Product Change Notice (PCN)

PCN Number: PCN-0450965R-01

Product(s) Affected: *MJ1-2503A*

Comparison plastic housing as below:

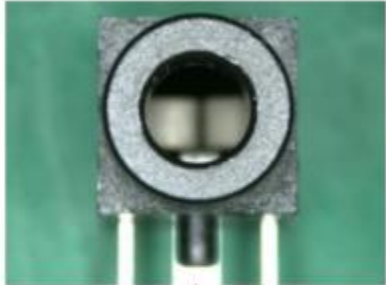
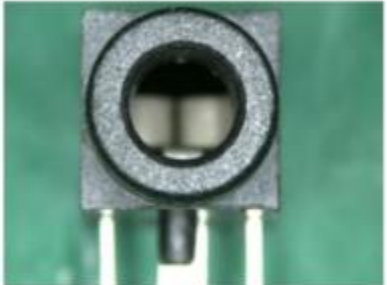
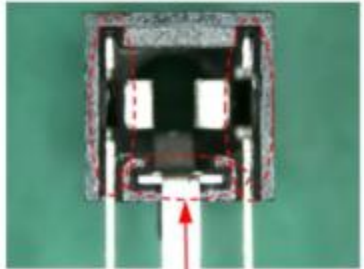
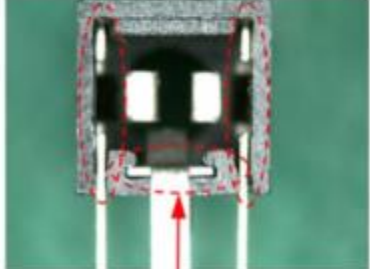
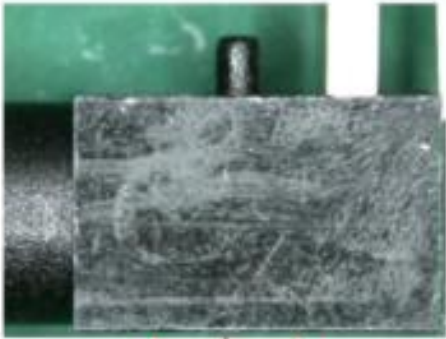
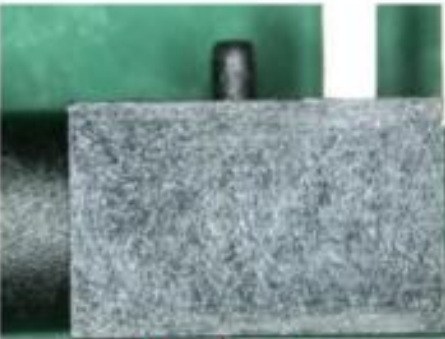
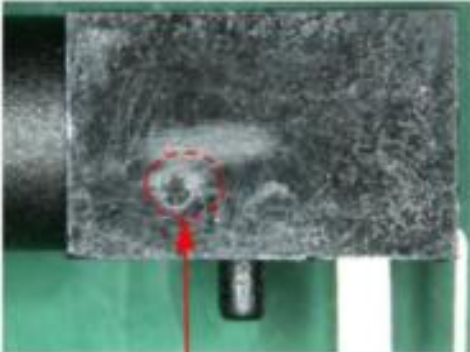
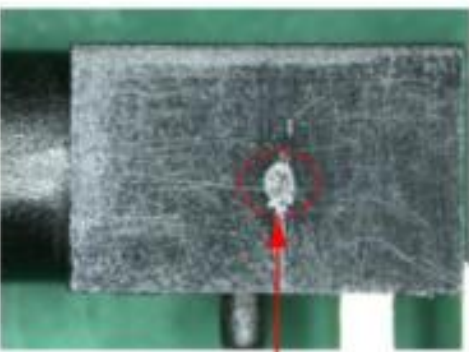
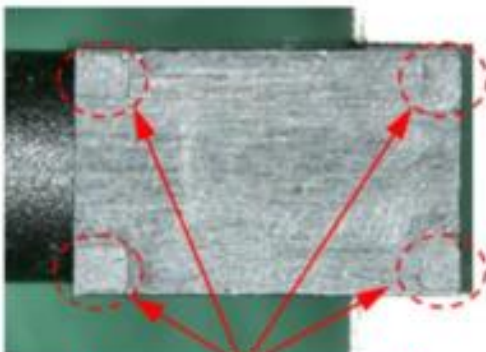
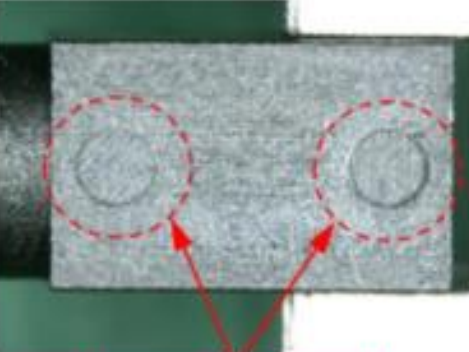
New version	Current version
Front	 <p>No change</p>	 <p>No change</p>
Back	 <p>add Chamfer</p>	 <p>No Chamfer</p>

<p>Left</p>	 <p>No change</p>	 <p>No Change</p>
<p>Right</p>	 <p>Injection point</p>	 <p>Injection point</p>
<p>Top</p>	 <p>with four square marks</p>	 <p>with two circle marks</p>
